Service Note		
Product	Description:	Service note no.
VoiceLive	Micro controller change	SNo- T102

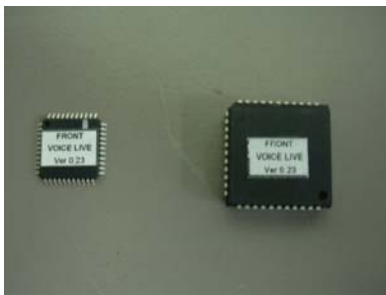
Due to a change in micro controller we can not provide the "old" type (big) of micro controller any more.

We can provide you with the "new" type (small) of micro controller.

The difference is the size and the fact that the old fits into a socket, so please make sure you check witch type you need before ordering this item.(see picture below).

Small is the new type.

Big is the old type.

In case you need the old type you must replace the complete board order item no: 7B81120002.

In case you need the new type you order item no: 7E49001501
